Water Right Conditions Tracking Slip

Groundwater/Hydrology Section

FILE # # G-17011

Reviewer: Karl Wozniak

Well Location Map (Shows only a partial representation of geologic structures. Refer to original USGS maps for details).

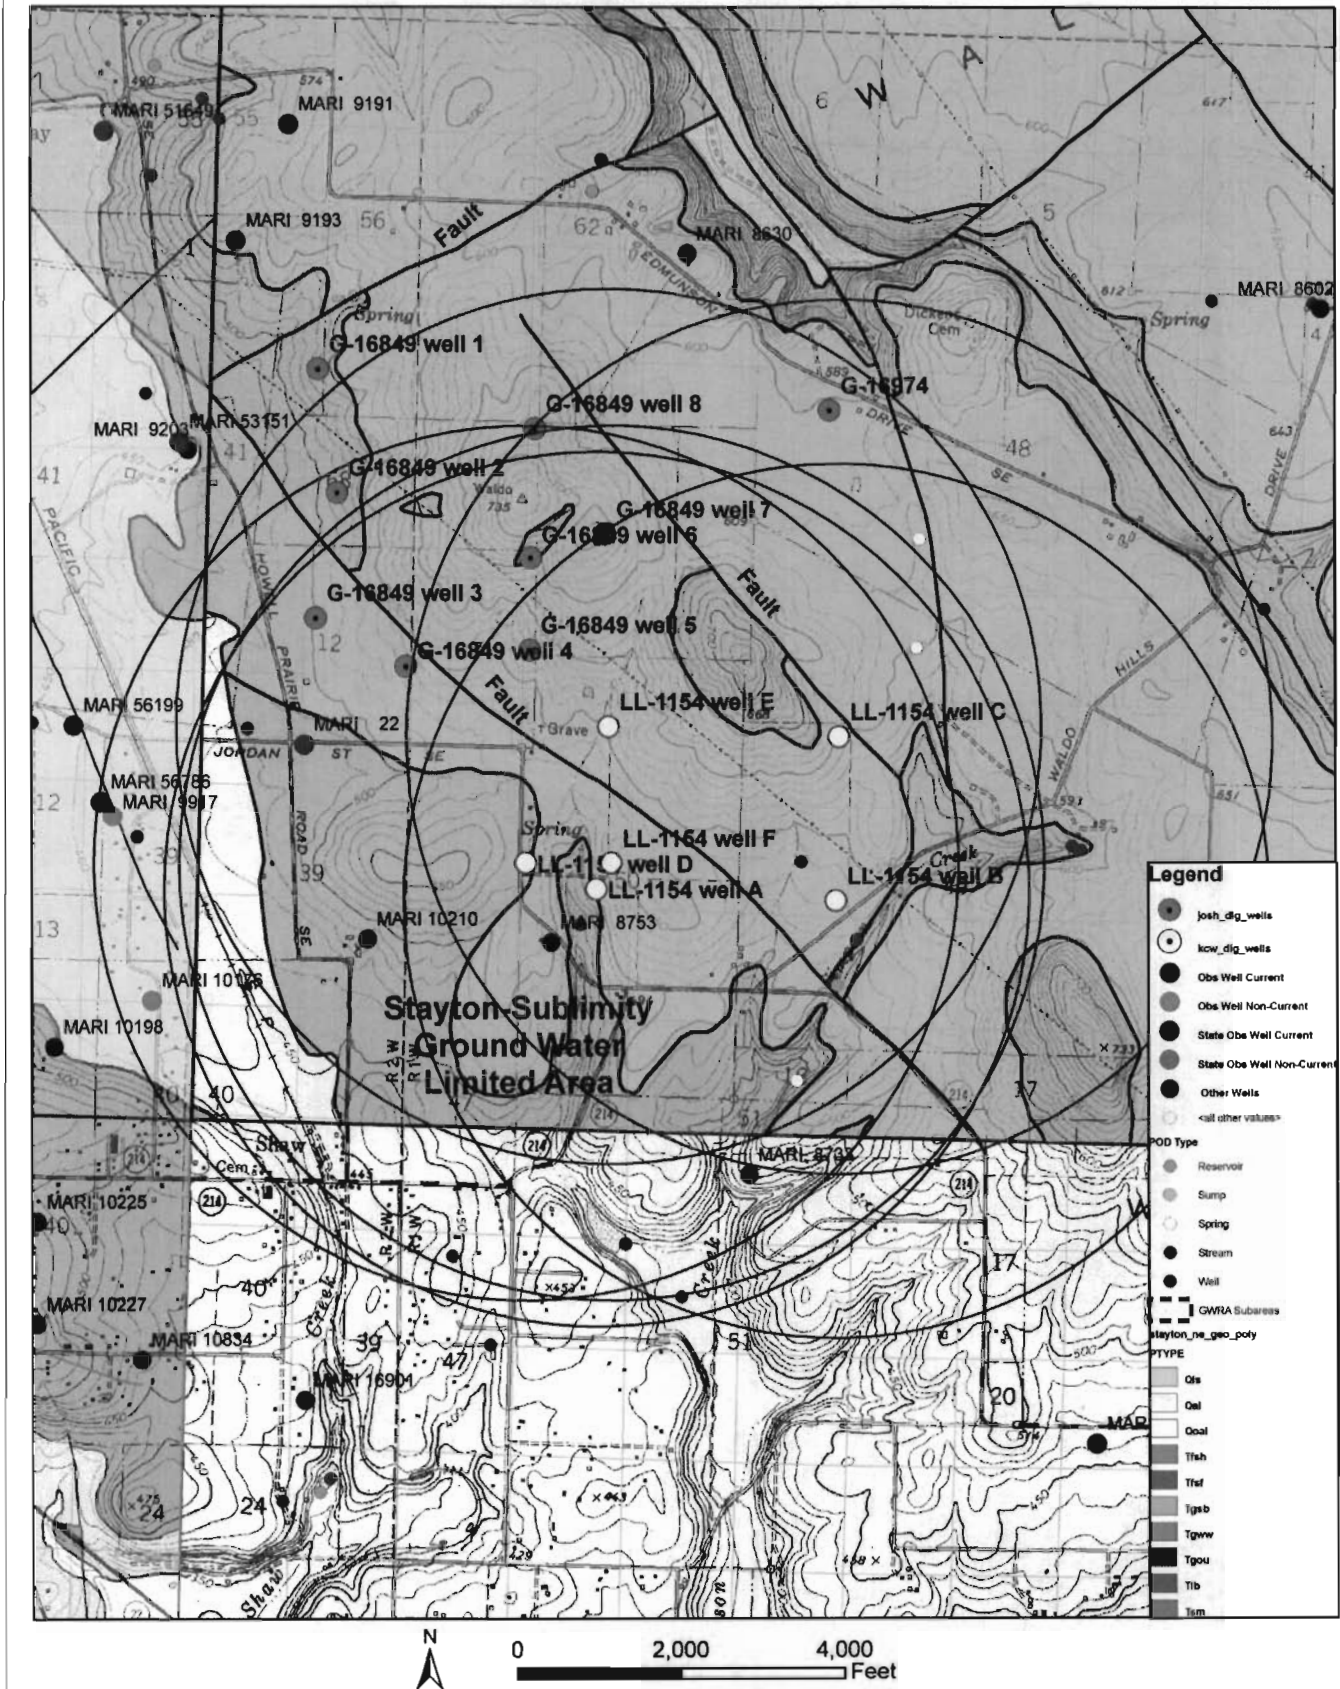
Proposed wells 1 (D) and 3 (F) and proposed well A on LL-1154 fall on the same side of a northwest-trending geologic fault as permitted irrigation wells MARI 22 and MARI 56786. Water level data in a nearby observation well, MARI 56199, indicate a seasonal fluctuation of at least 80 feet (see attached plot). Most of this seasonal variation is probably caused by hydraulic interference from MARI 22 and MARI 56786 which are the nearest irrigation wells in the same fault block. The long-term water-level trend in MARI 22 suggests that water levels have declined about 6-8 feet from the early 1990s through 2007 although much of this may be related to precipitation trends over the same period of time. This hint of instability and the large hydraulic interference that occurs seasonally on the south side of the fault suggest that excessive hydraulic interference is likely in existing wells if three additional large-capacity irrigation wells are permitted in the same area on the south side of the fault. (If the fault is a barrier to horizontal flow, as seems likely, it will increase the mutual interference between wells on the same side of the fault). The presence of the fault is also likely to result in greater impacts within the Stayton-Sublimity Ground Water Limited Area which is less than 1 mile to the south of proposed wells 1 (D) and 3(F) and well A on LL-1154.

Therefore, it is recommended that only one of the three wells be allowed with a production limit of 200 gallons per minute. Phone conversations with the applicants' agent, Ken Johnston, indicate that the applicants would prefer to drill proposed Well 1 (D) if only one of the three wells is allowed. Therefore, it was determined in Section B1 that water is not likely to be available from proposed well 3 (F) without injury to prior water rights and a condition was added to limit production to 200 gallons per minute from well 1 (D) to limit interference with existing wells.

1) Production from Well 1 (D) or any replacement well shall be limited to no more than 200 gallons per minute.
